HYUNDAI Technical Service Bulletin	GROUP Body	NUMBER 20-BD-013H-1
	DATE November, 2020	MODEL(S) Sonata (DN8a)
SUBJECT: WINDOW NOISE REPAIR

This TSB supersedes 20-BD-013H by updating the service procedure, adding the parts information section, and adding operation codes for parts replacement.

Description: This bulletin describes the procedure to diagnose and repair a window exhibiting noise while lowering and raising.

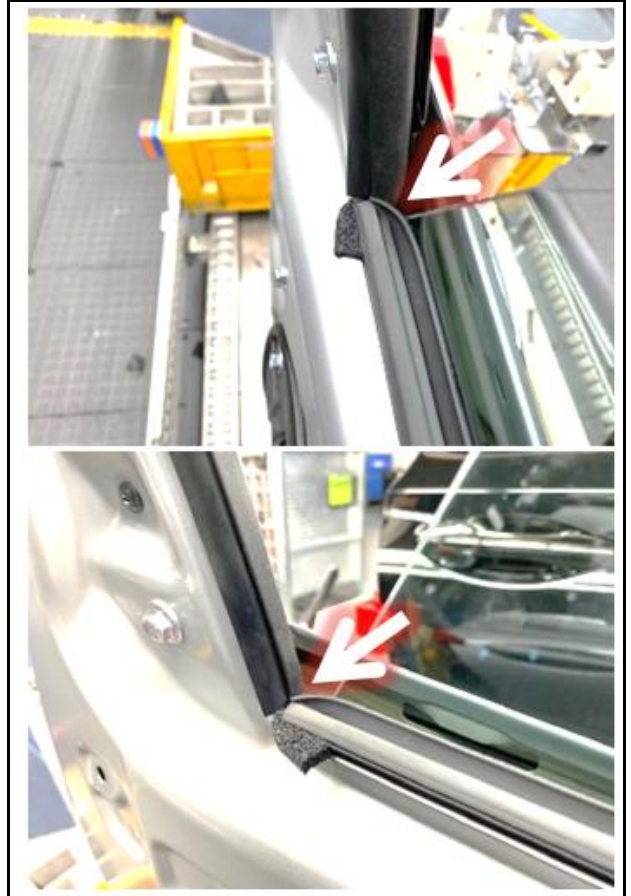
1. Inspect the glass run to determine if it is not seated.

2. Use a nylon/plastic trim removal tool to fully seat the glass run.

3. Inspect the belt molding and verify that the molding is fully seated and not underneath the glass run weather strip.

4. The belt molding should be aligned with the glass run weather strip.
